UNITED STATES NUCLEAR REGULATORY COMMISSION WASHINGTON, D. C. 20555

## ST. LUCIE PLANT UNIT NO. 1

#### AMENDMENT TO FACILITY OPERATING LICENSE

Amendment No. 104 License No. DPR-67

FIGURE 3.4-25 F. LUCIE UNIT I P/T LIMITS, 15 EFPY COOLDOWN AND INSERVICE TEST

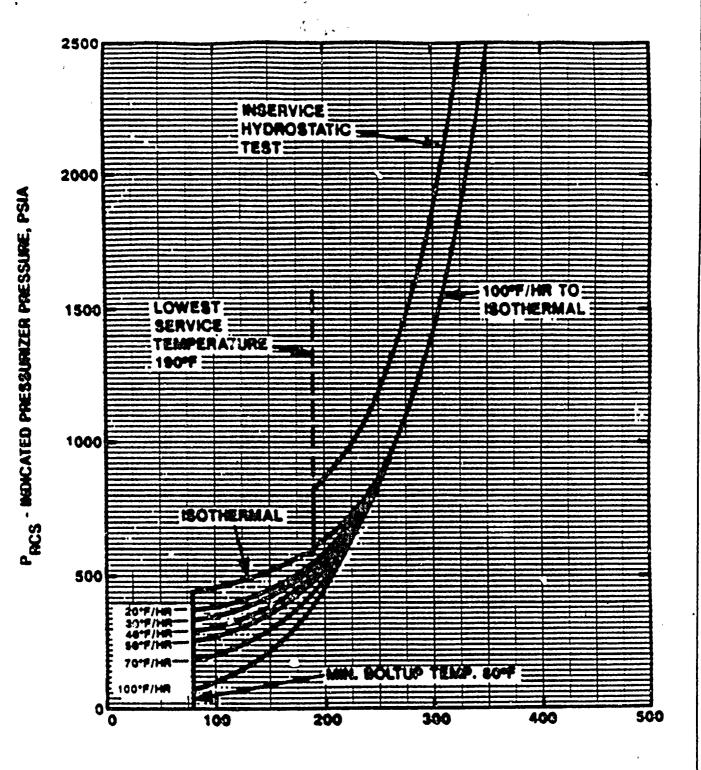
3.4.9.1 The Reactor Coolant System (except the pressurizer) temperature and pressure shall be limited in accordance with the limit lines shown on Figures 3.4-2a, 3.4-2b and 3.4-3 during heatup, cooldown, criticality, and inservice, leak and hydrostatic testing.

FIGURE 3.4-3 ST. LUCIE UNIT 1, 15 EFPY MAXIMUM ALLOWABLE COOLDOWN RATES

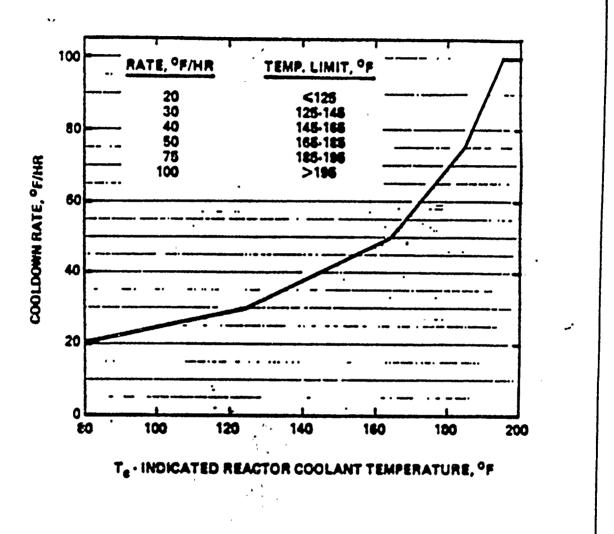
#### NOTE: A MAXIMUM COOLDOWN RATE OF 100°F/HR IS ALLOWED AT ANY TEMPERATURE ABOVE 190°F
